**Before the  
FEDERAL COMMUNICATIONS COMMISSION  
Washington, D.C. 20554**

In the Matter of )  
)  
Request by LoJack Corporation for a Partial ) WT Docket 06-142  
Waiver of Section 90.20(e)(6) and Part 2 )  
of the Commission's Rules )  
)

**Petition for Reconsideration of Hammett & Edison, Inc., Consulting Engineers**

This filing is in response to the Commission's September 14, 2011, *Declaratory Ruling and Order*, concerning Stolen Vehicle Recovery System (SVRS) stations at 173.075 MHz.

Representative Spectrum Figures from the Cited OET Report 07-TR-1003

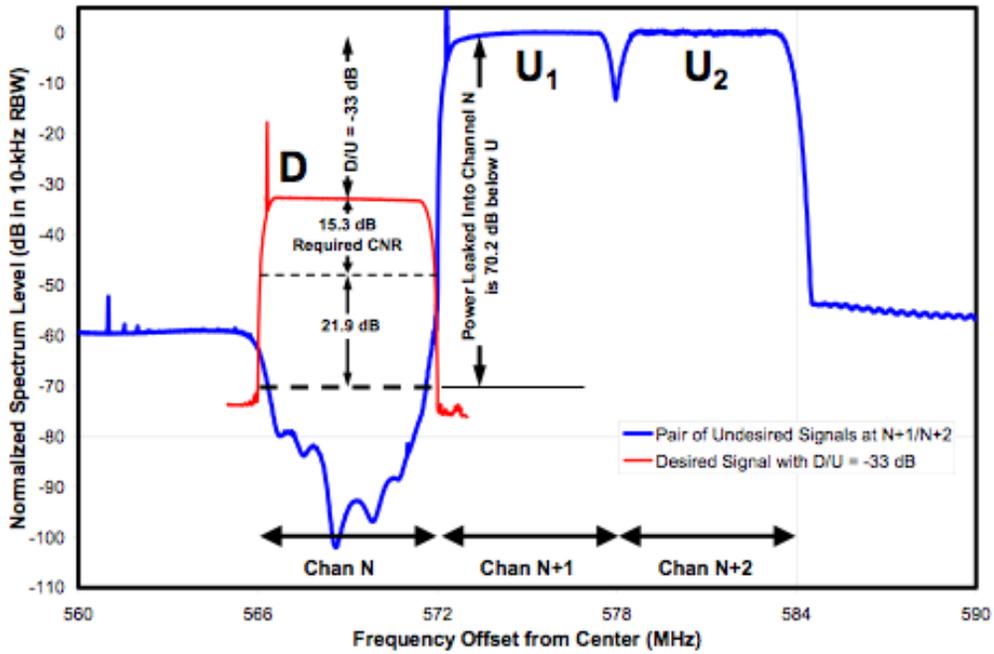
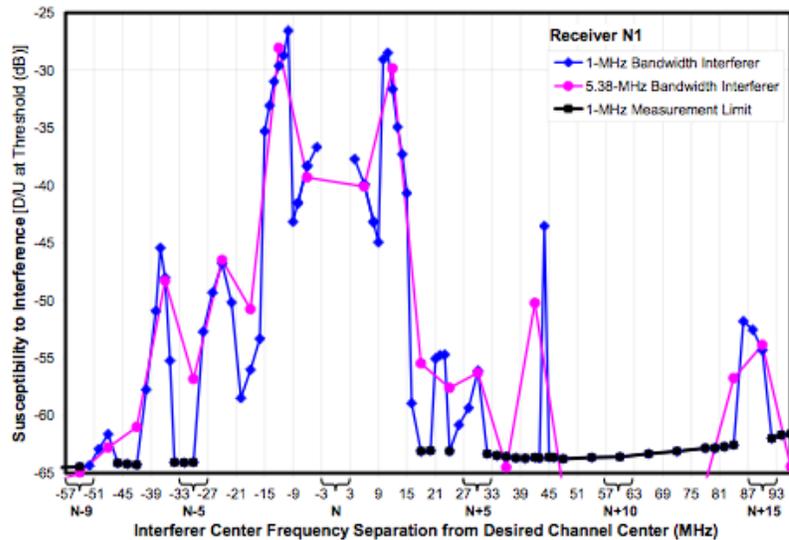
9. The vast majority of the OET testing was based on analog-into-DTV, and DTV-into-DTV testing; that is, one 6 MHz wide TV channel into another 6 MHz wide TV channel. Attached Figure 1 shows two representative spectrum figures from the OET Report. Although there was limited testing of a hypothetical Lower 700 MHz band interfering signal into a DTV Channel 51 receiver, that interfering signal was assumed to be a 1 MHz wide, noise-like signal.<sup>9</sup> A LoJack signal is not a 1 MHz wide, noise-like signal; it is a narrow band, concentrated energy signal. Further, as shown in OET Report Figure 7.1, at some frequencies a 1 MHz wide, noise-like signal was a greater interferer than a 6 MHz wide DTV signal. Therefore, the OET Report demonstrates that there is no basis for the optimistic assumptions made in the DR&O, such as that measurements at UHF would apply equally to measurements at VHF.<sup>10</sup> Indeed, although the OET Report did not include any VHF testing, the report does note that a prior OET investigation of DTV receiver performance for Satellite Home Viewer Extension and Reauthorization Act of 2004 (SHVERA) purposes<sup>11</sup> did include some VHF testing (for receiver sensitivity). But the OET Report notes, at page 5-4, that the SHVERA Report found that:
